Permit Number: 061426

has permission to New Single Family Home w/ car gara

AT ¹⁷8 STEPPING STONE LN #3

LOT 3 - GRADING PLAN
 AUTUMN GLEN SUBDIVISION

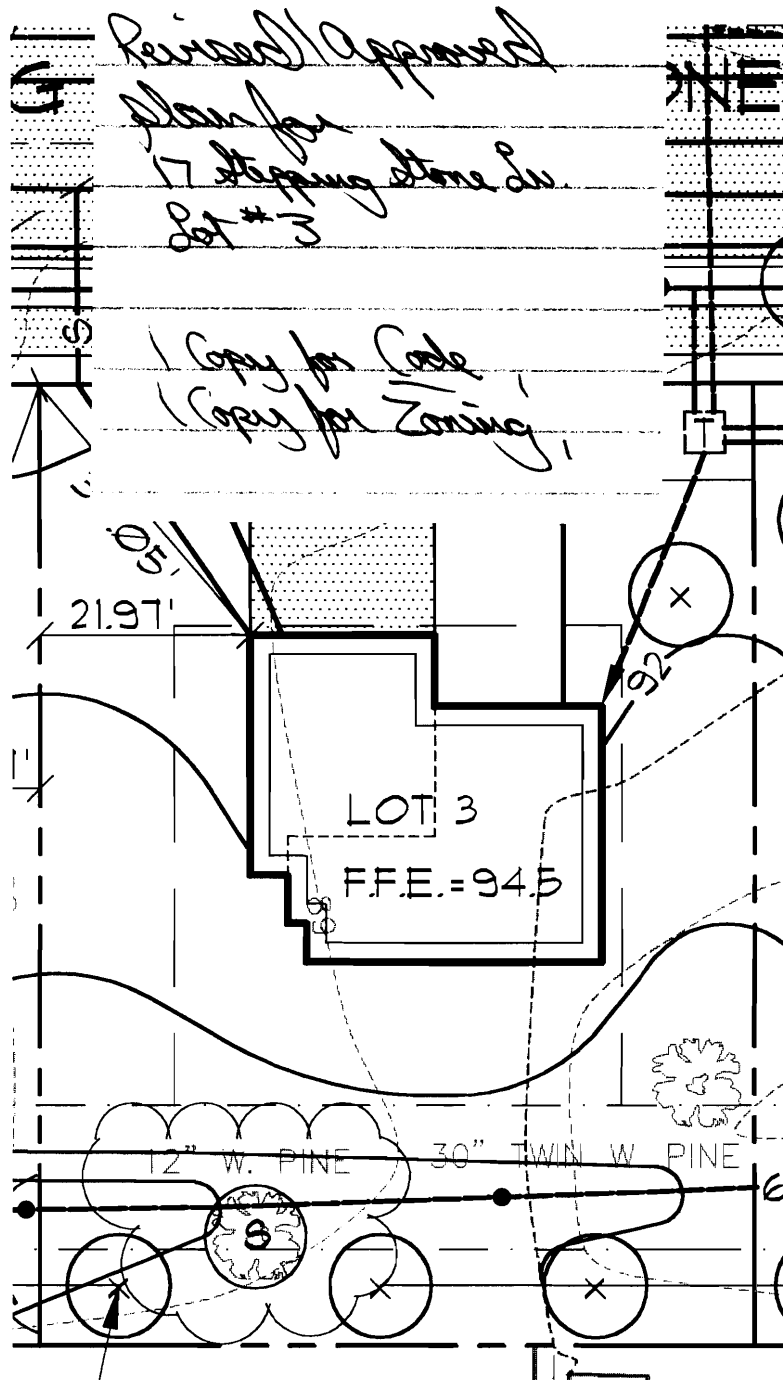
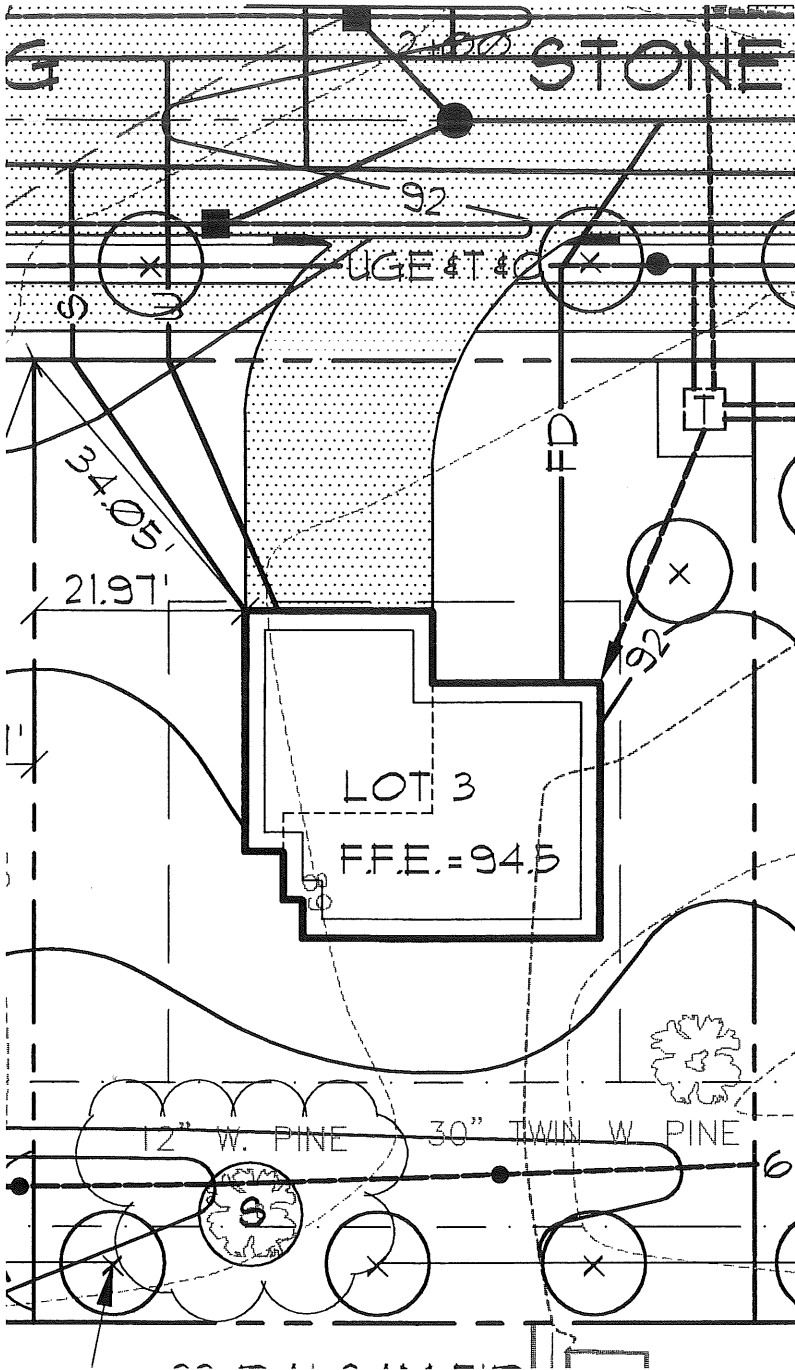
10/4/2006-amachado: Elevation plans show a daylight basement in the rear, but the gradin on the site plan does not. Left message for King Weinstein to call me.

LOT 3 - GRADING PLAN
AUTUMN GLEN SUBDIVISION

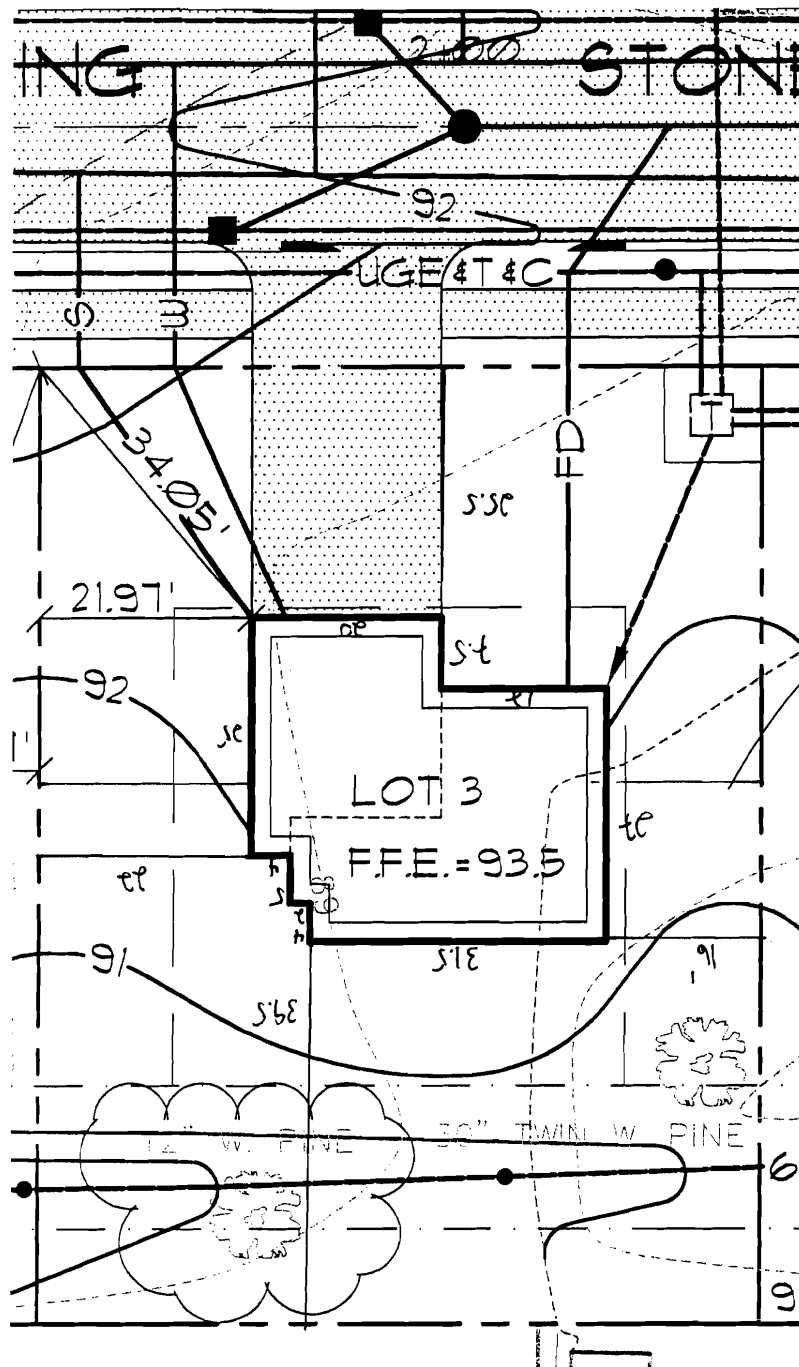
Lot Street Frontage - 50' min. - 75' given.

Front Yard - 25' req. - 25.5' scaled

Rear Yard - 25' req. - 39.5' scaled

Side Yard - ~~1 1/2 stories~~ 8' 16' on right OK ~~needed~~
11' 22' on left.

Height - 35' max. - ~~31.5~~ 22.25' scaled.

Lot Coverage Impervious Surface - 35% = 2625 OK
